Access Compliance Report Public Rights-of-Way (Pedestrian Signals)

Intersection ID: N/A	Main Street:	Cross Street: N/A	Location: N/A
ADA ID: 9E9A67CA73E2	Signal Type: Two Push Buttons-APS	Overall Compliance: No	Severity Score: BTN 1:N/A BTN 2: N/A No BTN: N/A
Codes/Mitigation Info/Possible Solution		Field Measurements/Component Compliance

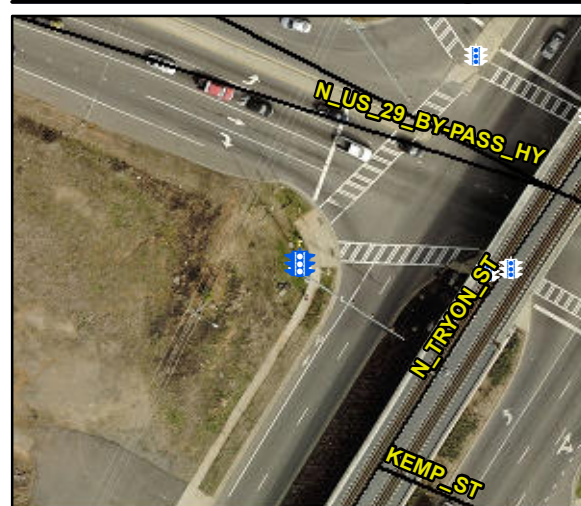
Surveyor Notes: TEXT HT 5/16

PROW/ADA: R410.6, TMUTCD 4e.08, R404.2, R404.3, R406.2, , R404.7.3

Possible Solutions: Replace Signal Push Button With APS Button on New Post. Remove & Replace Sign.
